MODEL
2011-2013MY
Sorento (XM)

NUMBER
041

TECHNICAL SERVICE BULLETIN

SUBJECT: FRONT STRUT AND DUST COVER REPLACEMENT

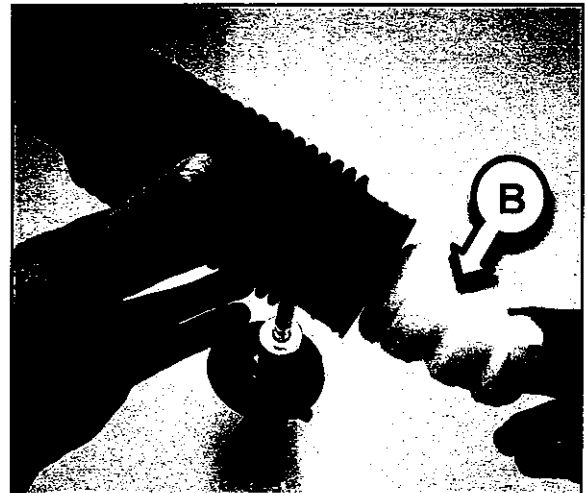
1. Remove and disassemble the front strut assemblies by referring to the service procedures in the applicable Workshop Manual on KGIS.
2. Remove the dust cover (A) from the strut shaft.

3. Remove the bump stop (B) from inside the dust cover.

Discard the dust cover and the strut.

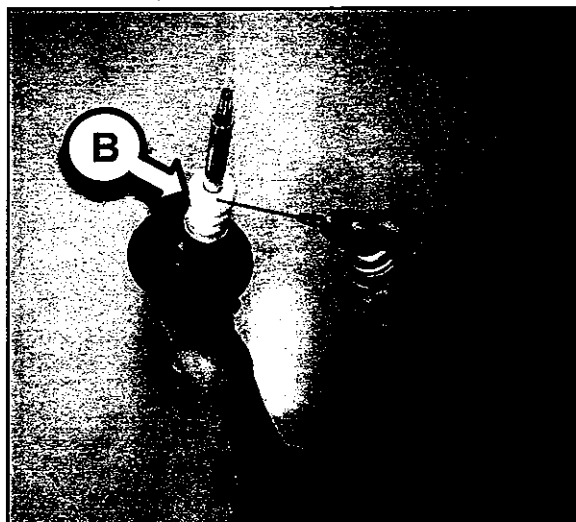
4. Install the bump stop (B) onto the new strut. Make sure to push the bump stop down until it makes contact with the strut body.

Apply a small amount of lubricant around the top of the bump stop in order to allow for easier installation of the dust cover.

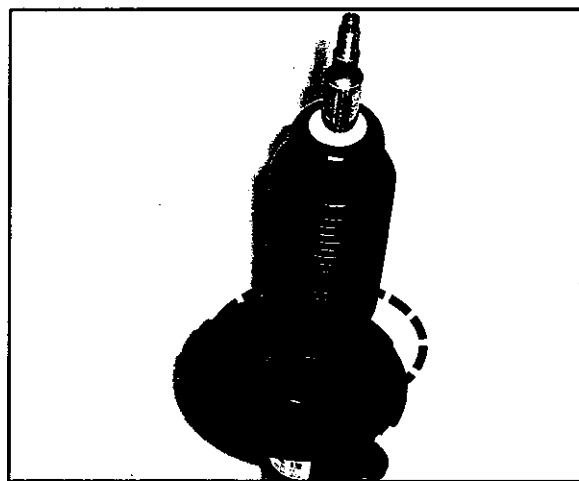
5. Install the dust cover onto the bump stop. Make sure the bump stop is properly seated inside the dust cover.

6. Pull the dust cover and bump stop until the bottom lip of the dust cover is slightly below the strut body.
